Entergy Nuclear Operations, Inc.
Pilgrim Nuclear Power Station
600 Rocky Hill Road
Plymouth, MA 02360

SUBJECT: Entergy Nuclear Operations, Inc.
Pilgrim Nuclear Power Station
Docket No. 50-293, License No. DPR-35

Response to NRC Request for Additional Information Related to Third Ten-Year Pilgrim Relief Request, PRR-42, Examinations of Component Welds with Less Than Essentially 100% Examination Coverage

RESPONSES FOR PRR-42 RAI (PRR-42 Rev. 1)

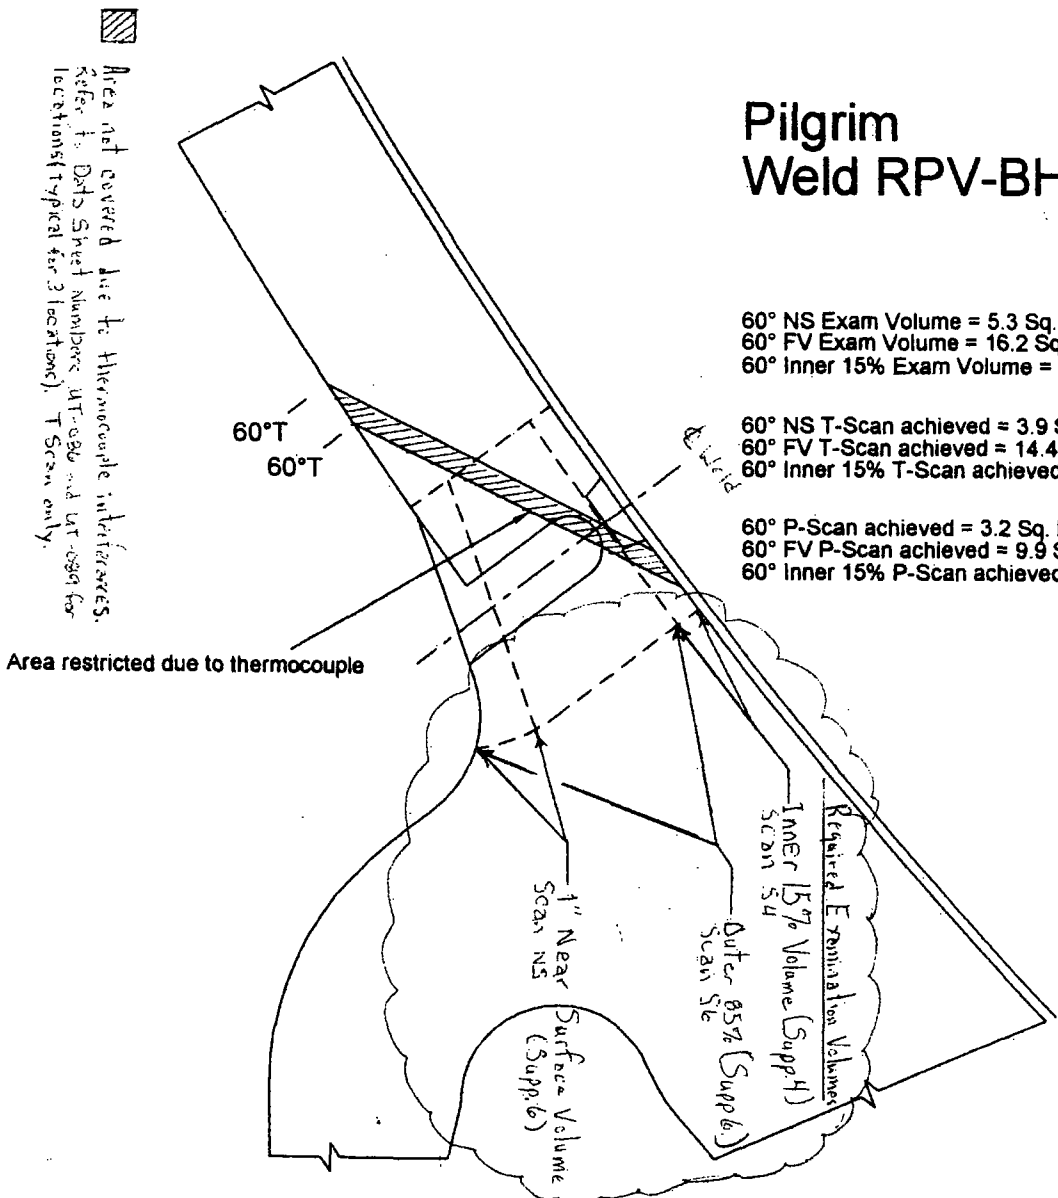
Area not covered due to thermocouple interference.
Refer to Data Sheet Number: UT-080 and UT-089 for
locations (typical for 3 locations). T-Scan only.

Sketch 3

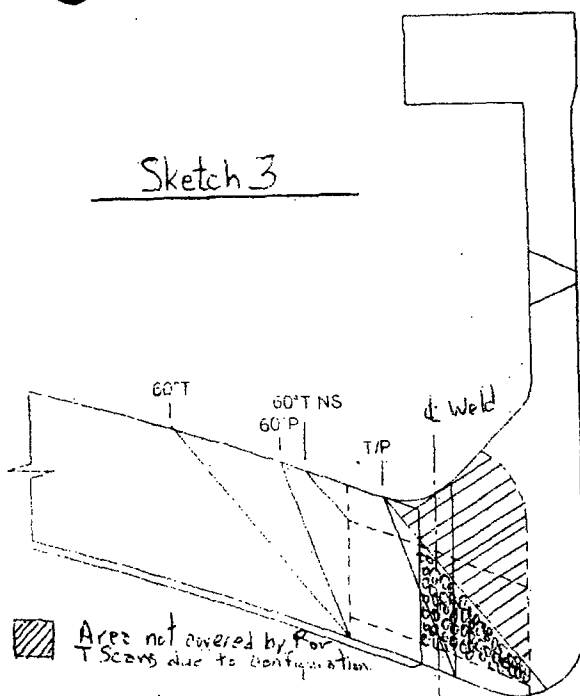
- Area not covered by P Scan due to configuration
- Area not covered by T Scans due to configuration
